SUNDRY NOTICES AND REPORTS ON WELLS (DO NOT USE THIS FORM FOR PROPOSALS TO DRILL OR TO DEEPEN OR PLUG BACK TO A DIFFERENT RESERVOIR. USE "APPLICATION FOR PERMIT" (FORM C-101) FOR SUCH PROPOSALS.)		WELL API NO. 30-025-23566
1. Type of Well: Oil Well ☐ Gas Well ☐ Other INJECTION		5. Indicate Type of Lease STATE ☒ FEE ☐
2. Name of Operator CROSS TIMBERS ENERGY, LLC		6. State Oil & Gas Lease No.
3. Address of Operator 400 W 7TH ST, FORT WORTH, TX 76102		7. Lease Name or Unit Agreement Name NORTH VACUUM ABO UNIT
4. Well Location Unit Letter <u>J</u> : <u>1807</u> feet from the <u>S</u> line and <u>1880</u> feet from the <u>E</u> line Section <u>14</u> Township <u>17S</u> Range <u>34E</u> NMPM County <u>LEA</u>		8. Well Number 142
11. Elevation (Show whether DR, RKB, RT, GR, etc.)		9. OGRID Number 298299
10. Pool name or Wildcat VACUUM; ABO, NORTH

Vacuum ABO Unit #142

Action 520677

Operator: CROSS TIMBERS ENERGY, LLC 400 West 7th Street Fort Worth, TX 76102	OGRID: 298299
	Action Number: 520677
	Action Type: [C-103] NOI Workover (C-103G)

PROPOSED

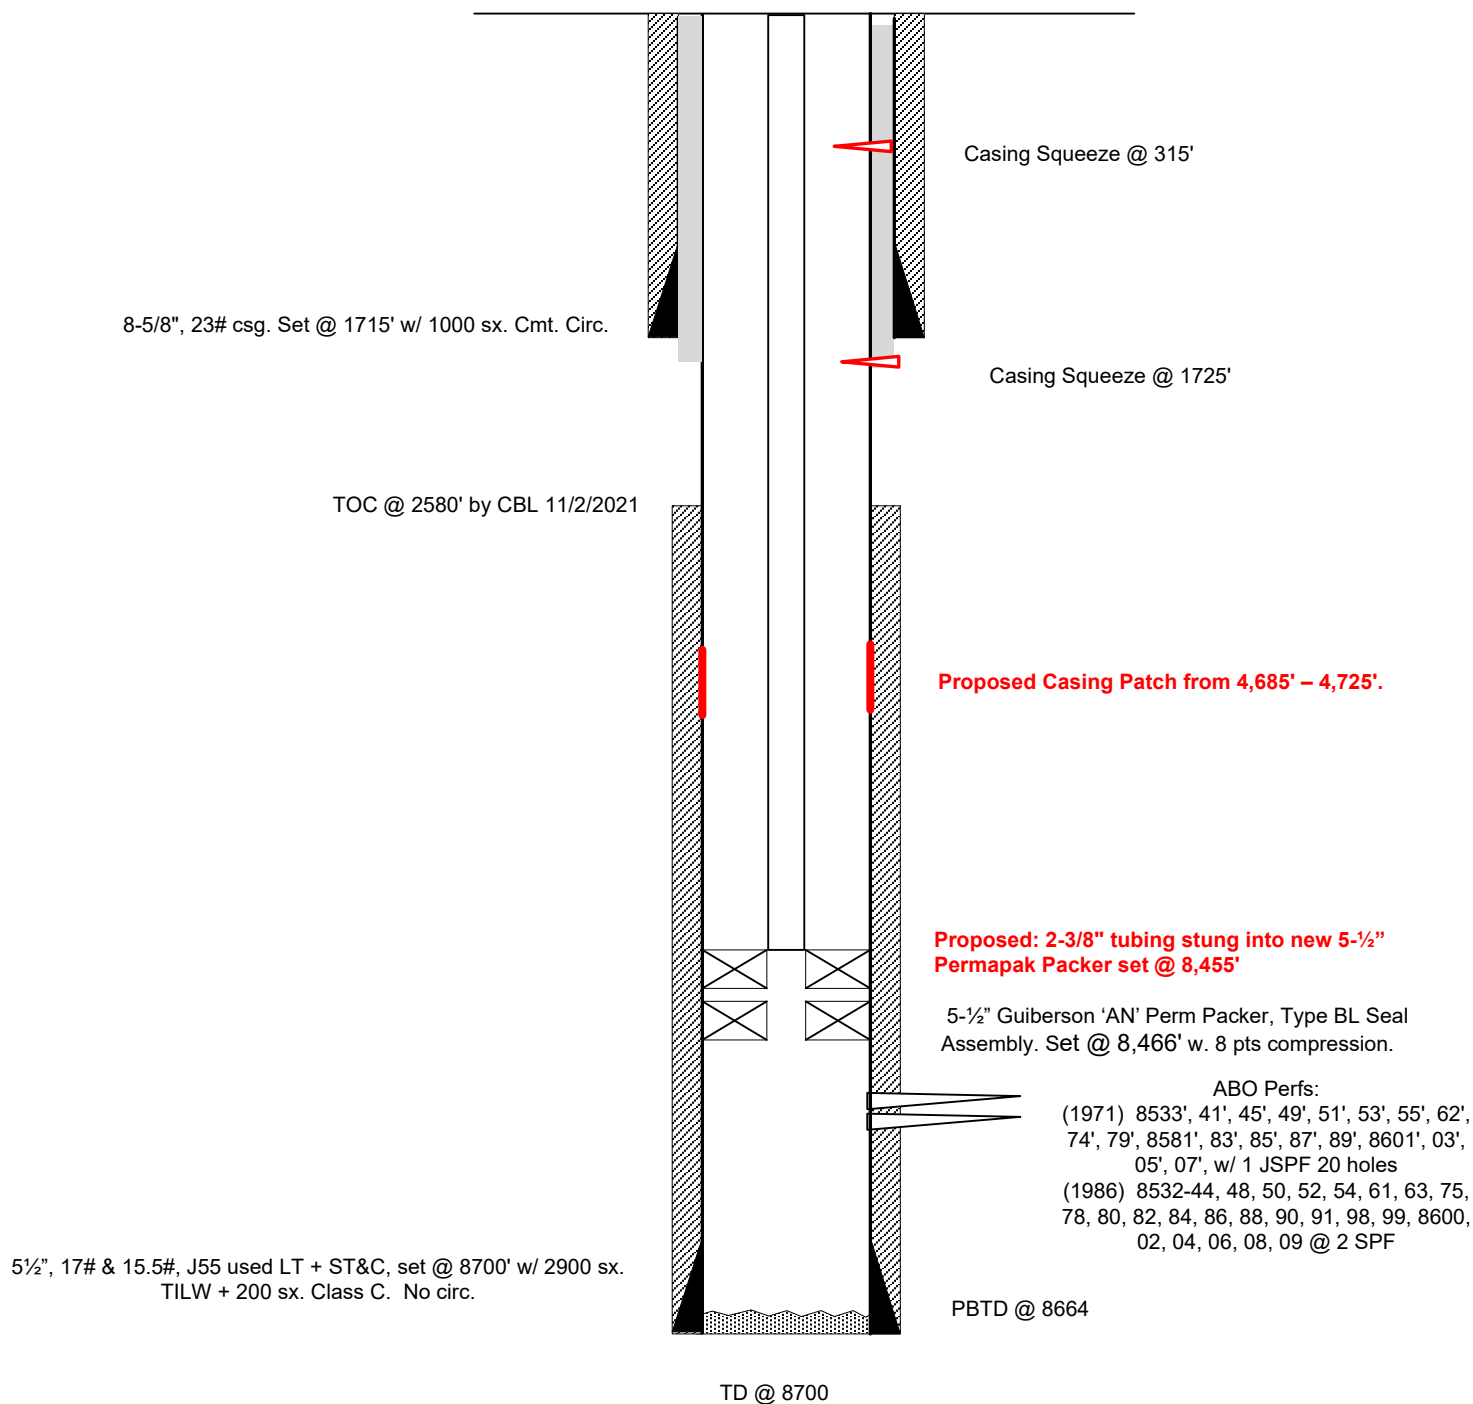
Created By	Condition	Condition Date
anthony.harris	Post workover MIT required with OCD witness	11/25/2025
anthony.harris	Submit Post workover C-103 Subsequent Report to summarize the work performed. Attach an updated wellbore diagram showing tubing details, packer setting depth and casing patch details (setting depth(s), Outside Diameter, Inside Diameter)	11/25/2025
